SUBJECT: SUMMARY OF MARCH 4, 1982 MEETING ON HEARING SCHEDULES

AUXILIARY BUILDING AND FIVP CONFIRMATORY ISSUES

Subject: Identification of Geotechnical Engineering Section's Review Concerns Prior to Initiating Phase 2 Underpinning Work
MIDLAND - AUXILIARY BUILDING

QUESTIONS RELATING TO
AUXILIARY BUILDING UNDERPINNING
AUDIT OF MARCH 16-19, 1982

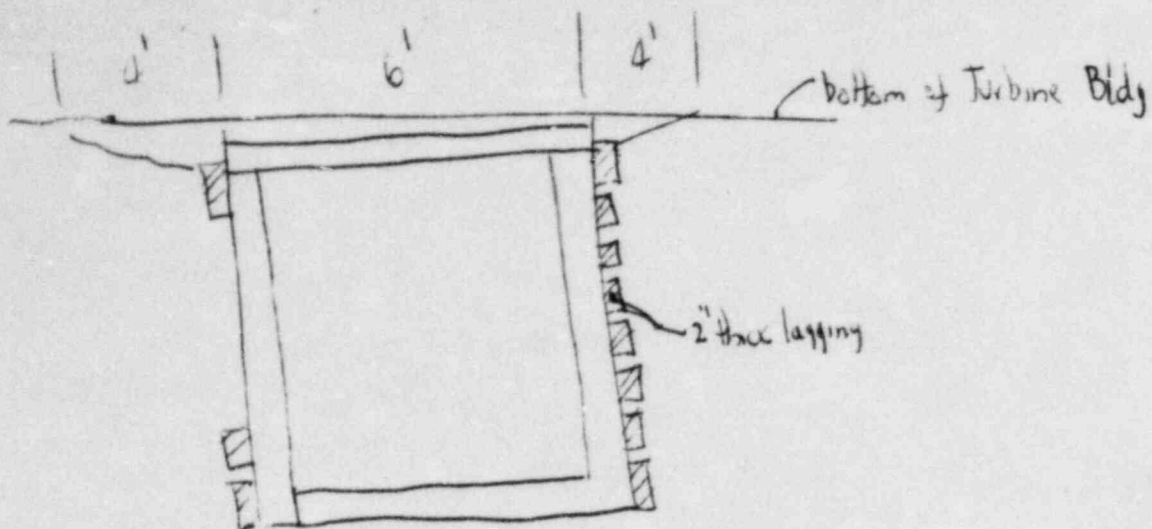
Concern for extensive concrete left in place around reactor perimeter. Changing up piers and time to remove also per on west side of EPA would minimize access to EPA & control tower

1. The removal of soil support beneath the EPA prior to support the end opposite the control tower seems to be too extensive. Is there any way to reduce the amount of removal, e.g., by placing piers directly under the end of the EPA rather than using the needle beam system?

2. The FIVP is now supported on the buttress access shaft and on the turbine building. Therefore, it will be necessary to monitor the vertical movement of the FIVP relative to the reactor containment and relative to the turbine building more frequently than every 8 hours during initial excavation stages. The vertical and horizontal movement of the buttress access shaft relative to the reactor should also be monitored more frequently than every 8 hours when soil is removed adjacent to the buttress access shaft.

3. Please review the stress changes in the main auxiliary building when the EPA acts as a propped cantilever with no soil support.
4. How far off center from the turbine building columns are the new piers near the long access drift? Is it reasonable to move the drift to the south about 8 ft thereby reducing the loss of support under the EPA and permitting these turbine building piers to be centered? *Moving drift further south causes heavy crane loads*

5. What material will be used as backpacking behind lagging in the drifts and piers? *- will be soil that has been removed - rammed w/ 2" x 4" to be pulled up*

6. Describe sequence of events in placing a new set and lagging in the drift. *- 10" high board - 1" spacer below for drainage - 2 in 4' length) 2" thick lagging*

7. How will the electrical ducts under the control tower be supported?
8. Monitor absolute vertical movement of ~~turbine building~~ ^{control tower} more frequent than every 8 hours as the drift approaches the control tower and during installation of the first few CT piers.
